Carolina Power & Light Company

SUBJECT: Senior Reactor Operator Written Examinations

NRC EXAMINATION COMMENTS

H. B. ROBINSON SRO CLASS 87-1

DRAWING TITLE: LOGIC DIAG.  
Nuclear Instr. Permissives & Blocks  
DRAWING NO. CP-300-6375-2755  
Rev. C

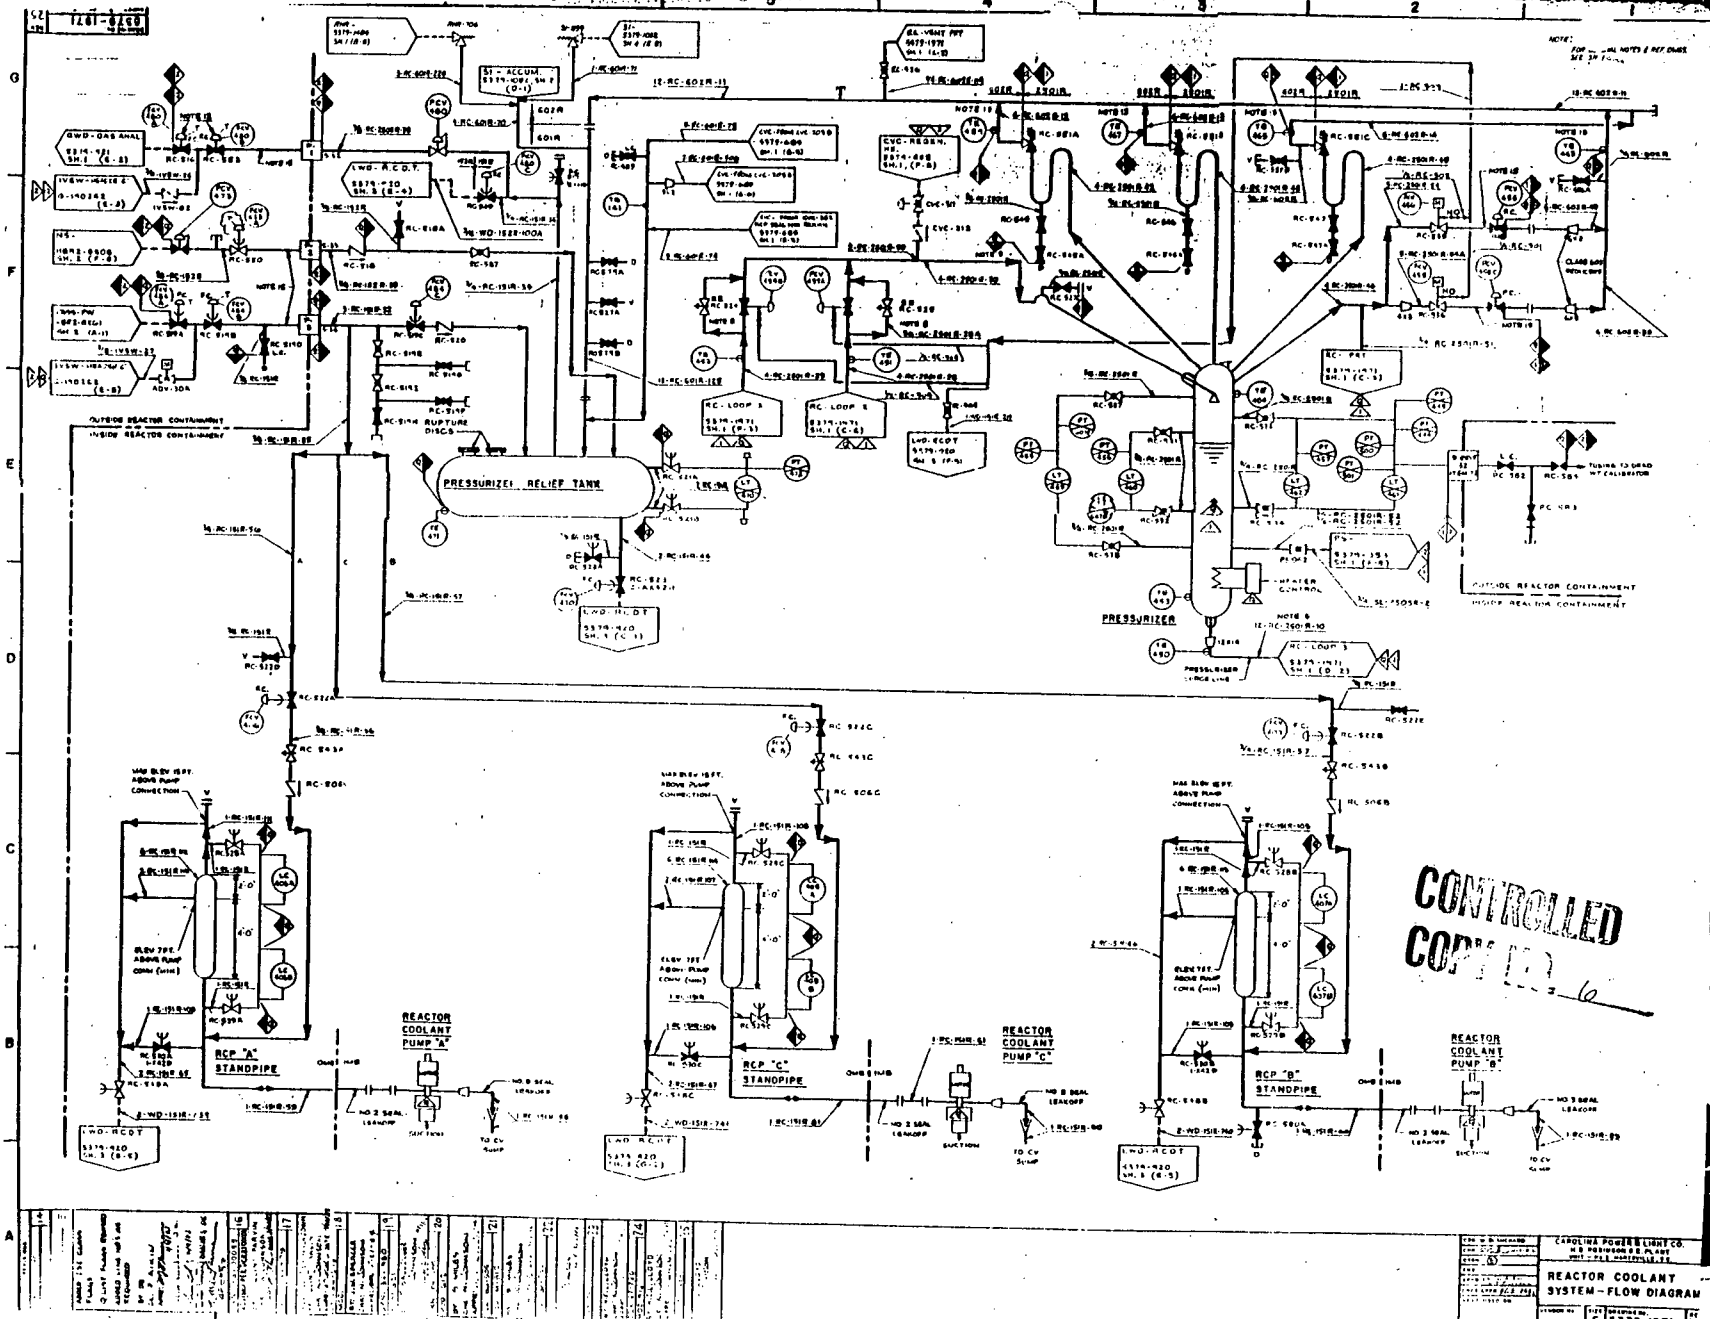
Parts 1 and 2. Recommend accepting NIS rod drop signal or 5%/5 seconds since both terms are synonymous.

Part 2. Recommend accepting rod bottom signal from any rod or rod bottom signal from RPI.

DRAWING TITLE: LOGIC DIAG  
Feedwater Isolation

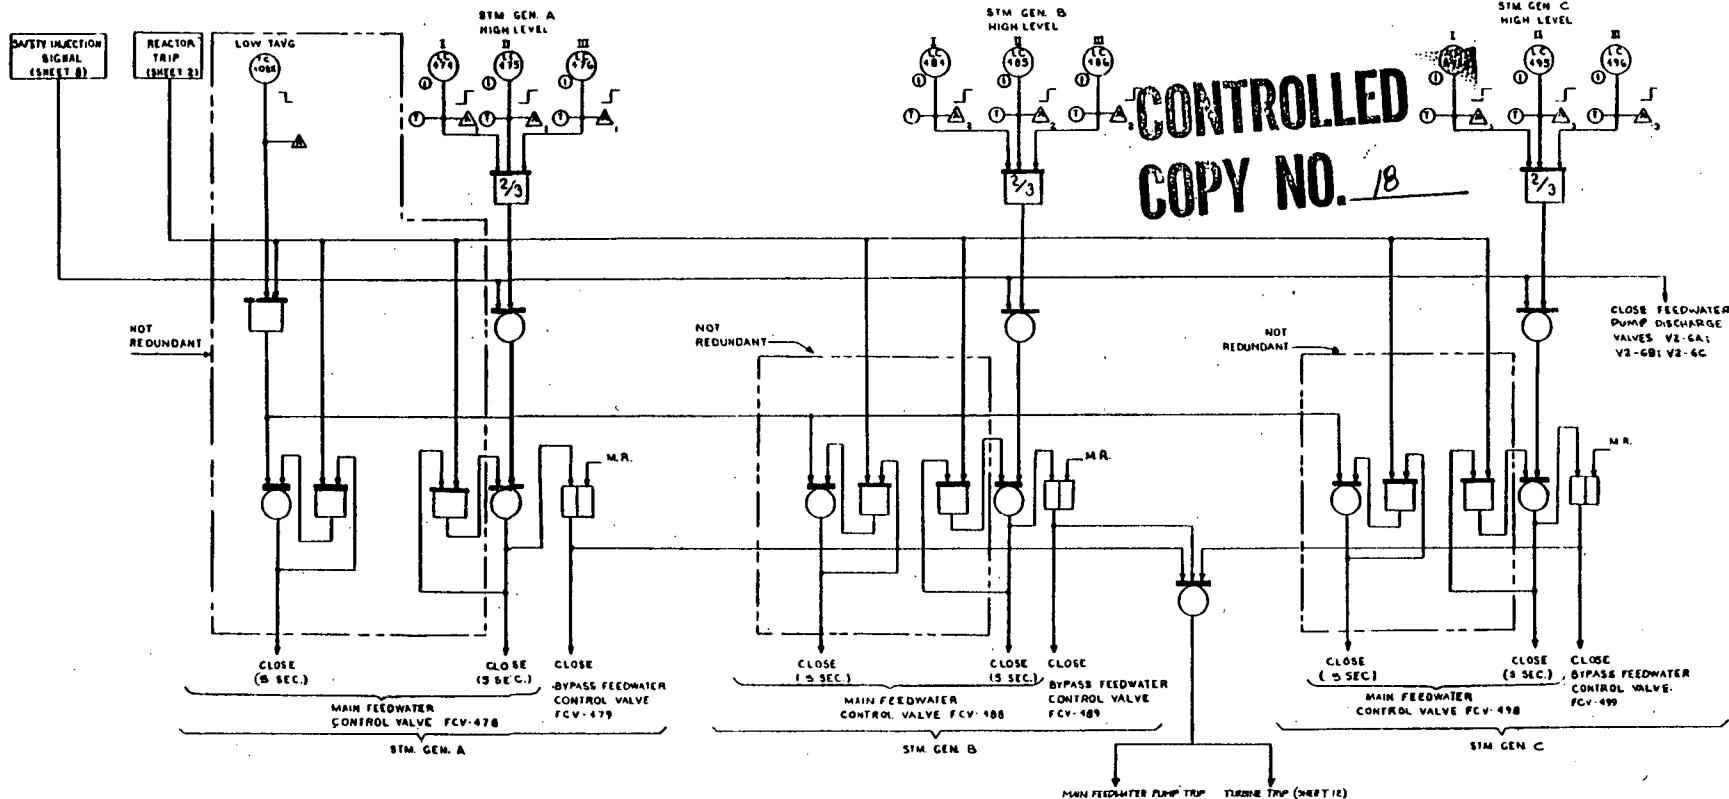
Recommend accepting as correct answer "A reactor trip and low TAVG or a safety injection signal or S/G high level".
